CAPP 2010-0002

New Residential Construction  
(deferred from February 16, 2010)

*Waterford Historic District*

# CAPP 2010-0002 | Madison Residence

Front Elevation

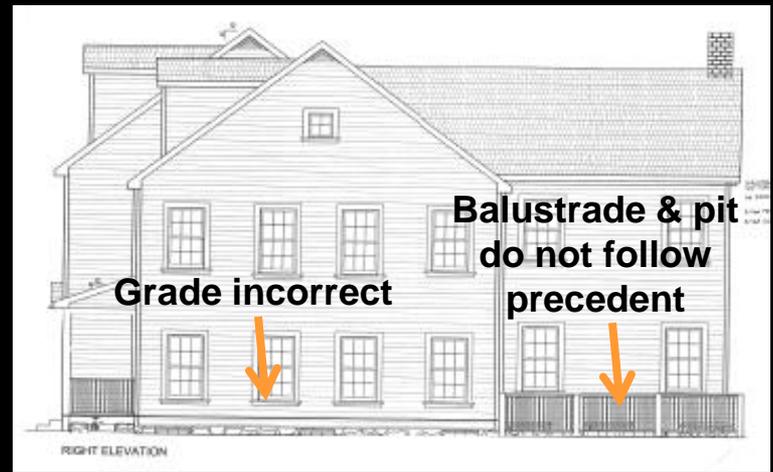
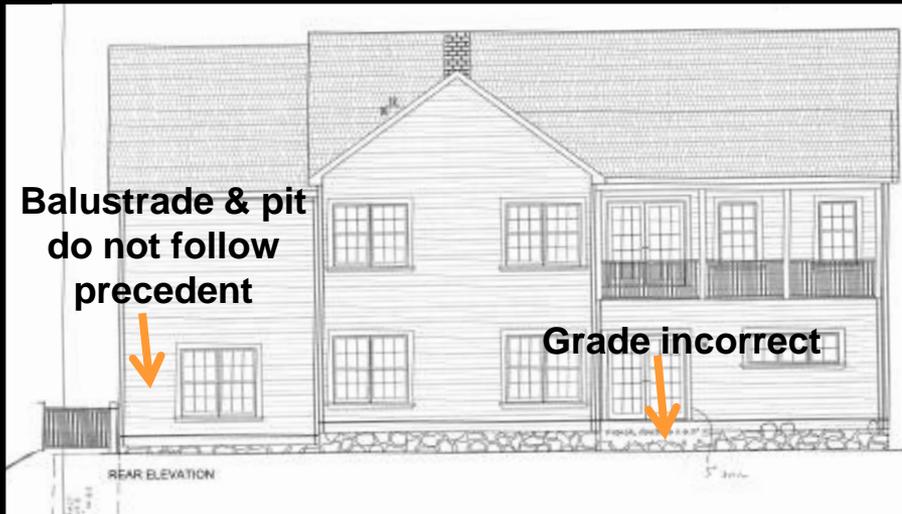
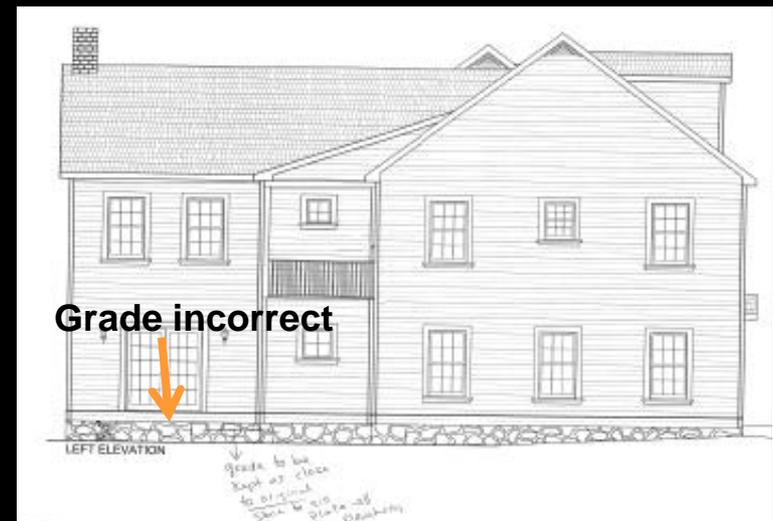
## Correct change in grade on all elevations

- Revised plans **do not show the correct change in grade** on all elevations
  - Notes on elevations seem to indicate grade to remain as close to existing as possible
- **Unclear** design and grade change **proposals**

- 1.) The correct change in grade on all elevations, a clear depiction of how the applicant proposes to address this change, including any exposed foundation and any necessary retaining walls, and removal of the proposed pit and surrounding balustrade,
- 2.) A building, including the main block, that is similar in massing, width, and scale to historic residences in the district of the same style and design (symmetrical, 5-bay, main block with a central entrance) and directional expression and on a similar lot size with similar setbacks,

## Front Yard Setbacks

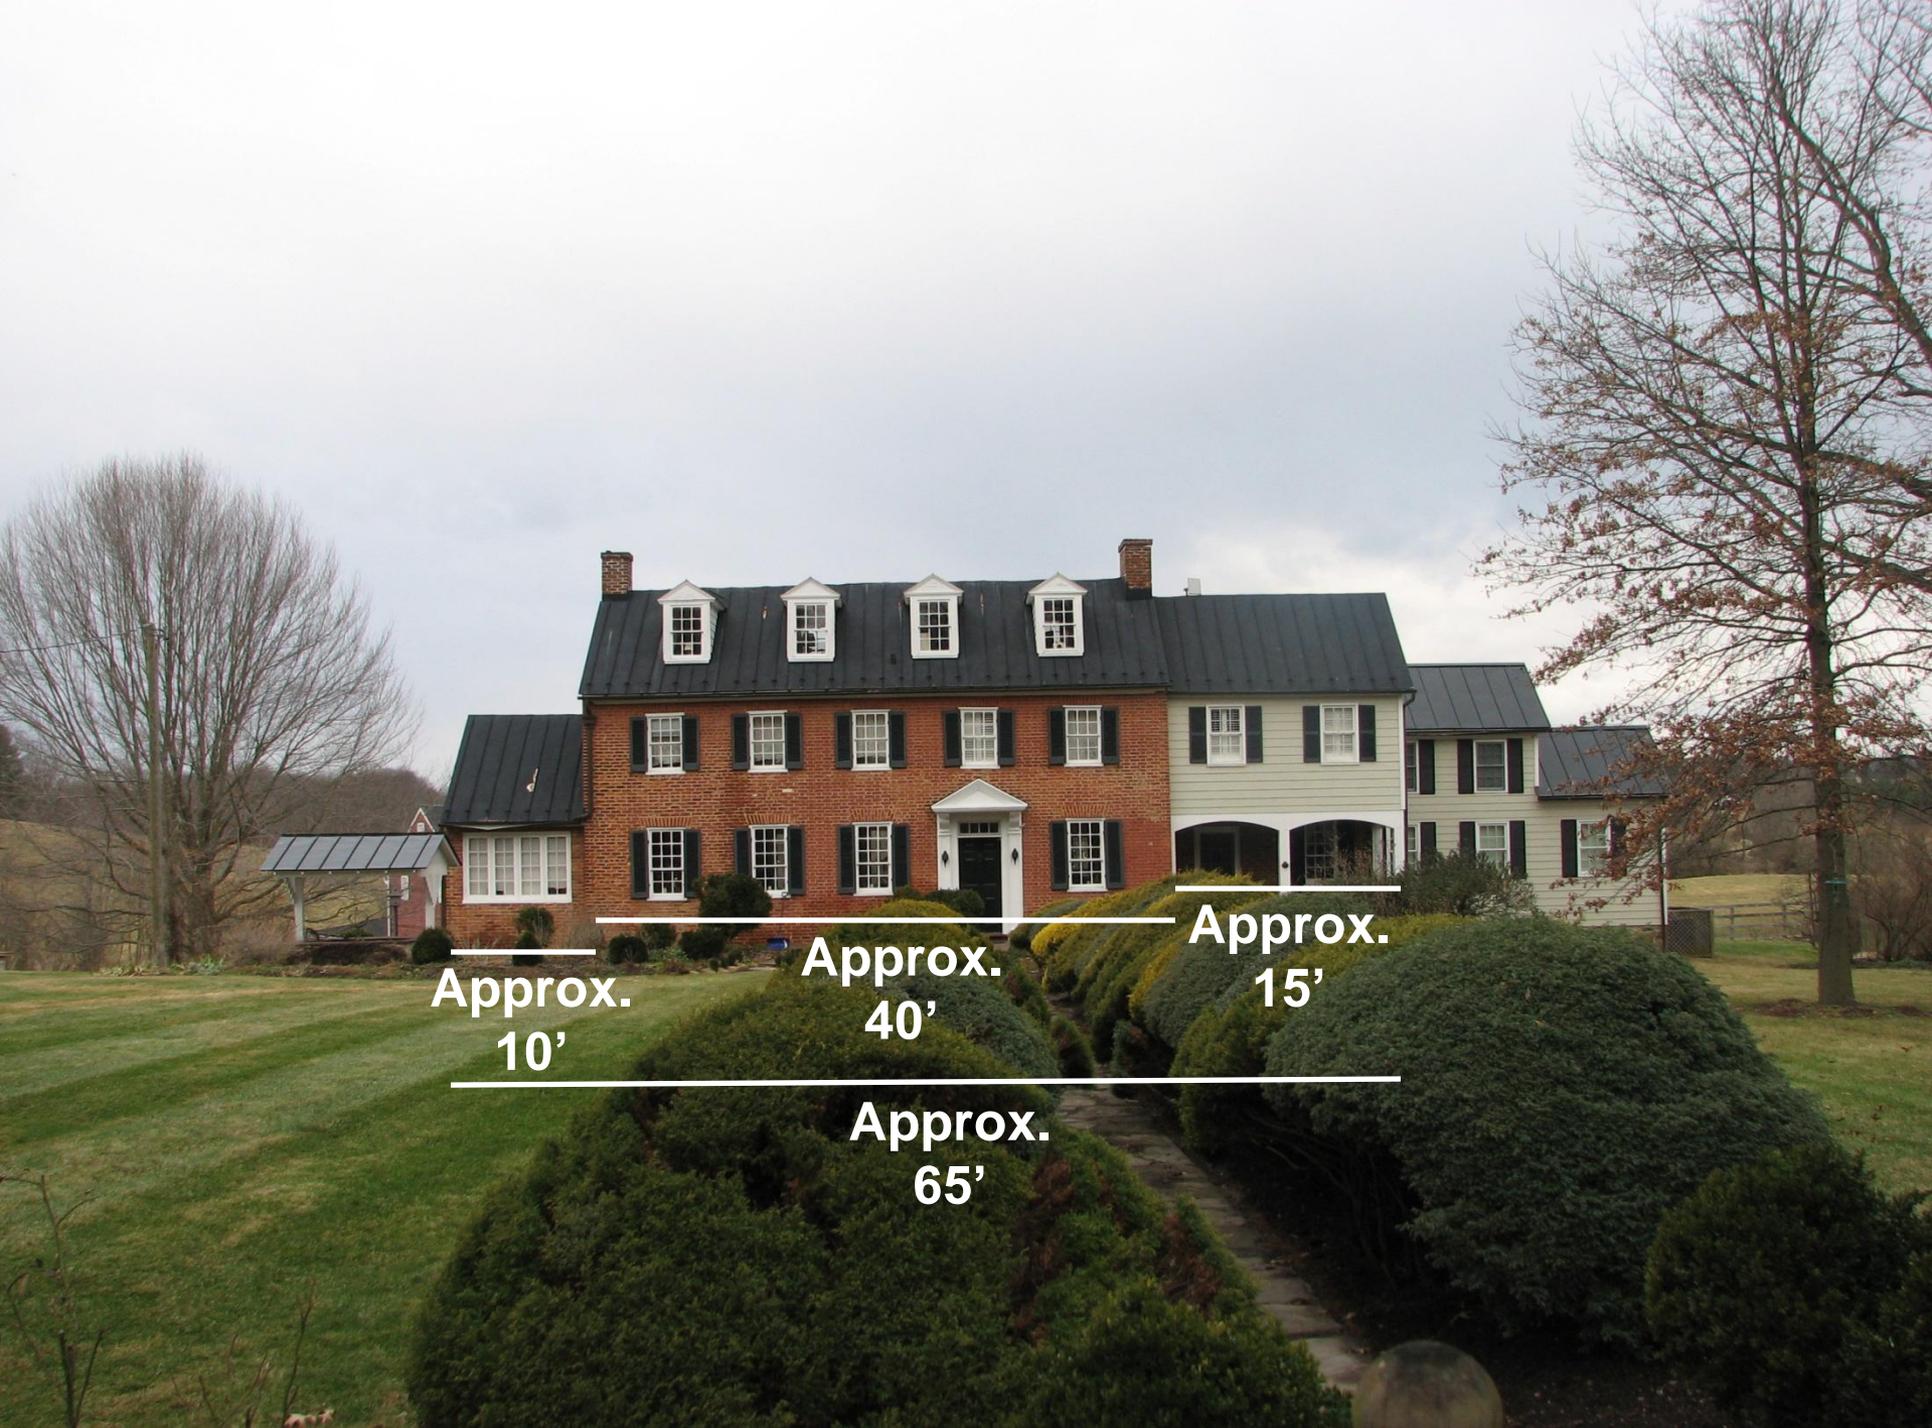
- 5.4 feet NW corner to 5.7 feet NE corner
- The same front yard setback as the house that formerly stood on the lot.

- The average setback of all primary buildings within 150 feet of the subject property on the same side of the street (8 feet )

Setback = 21'

- 1.) A plat with the revised proposed location based on VCOD and CR-2 setbacks and dimensions that meet the Zoning Ordinance lot coverage requirements,

## Massing, Width, and Scale

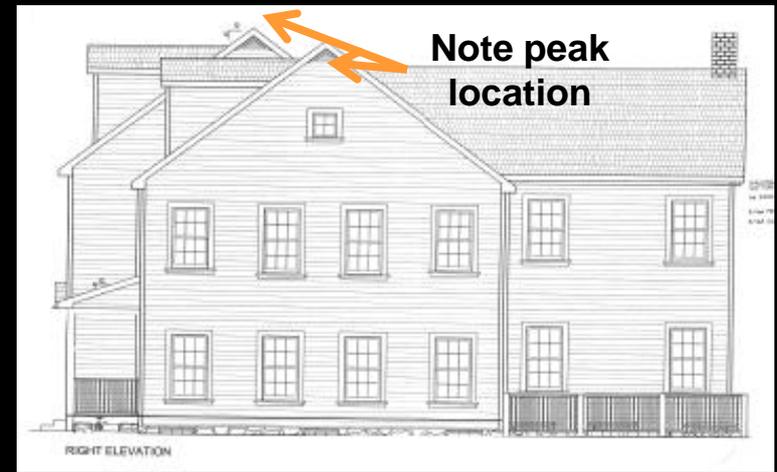
- Proposed main block (45' 3" x 30') and overall width (~61') are larger than neighboring historic and non-historic residences,
- Main block and overall width are larger than 5-bay historic houses with wings (vertical expression) on large lots and deep setbacks (main block approx. 40' wide x 20' deep) ,
- Main block and overall width are larger than 5-bay historic houses (horizontal expression) with shallow set backs on town lots

## Dormer Redesign

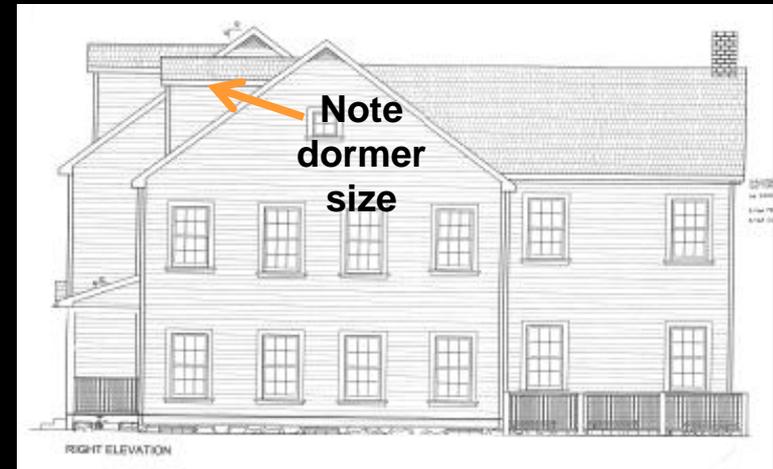
The **relocation** of the dormers is **successful** and meets the Guidelines

- Increased **dormer size** does not meet the Guidelines
- The dormers are not scaled proportionately to building
- Height does not follow historic precedent
- Creates massive dormer profiles on side elevations
- Lacking design details

- 5.) Complete detailed drawings for the proposed dormers, windowsills, front and rear porch details, stone front entry feature, rear entry steps, roof-wall junction (cornice and rake), and front door surround taking into account all recommendations made in the Staff Report. All details should relate to the formal, yet simple, design of the proposed house and follow traditional and historic precedents found in the Waterford Historic District, including the attachment of the rear enclosed porch to the rear roof.
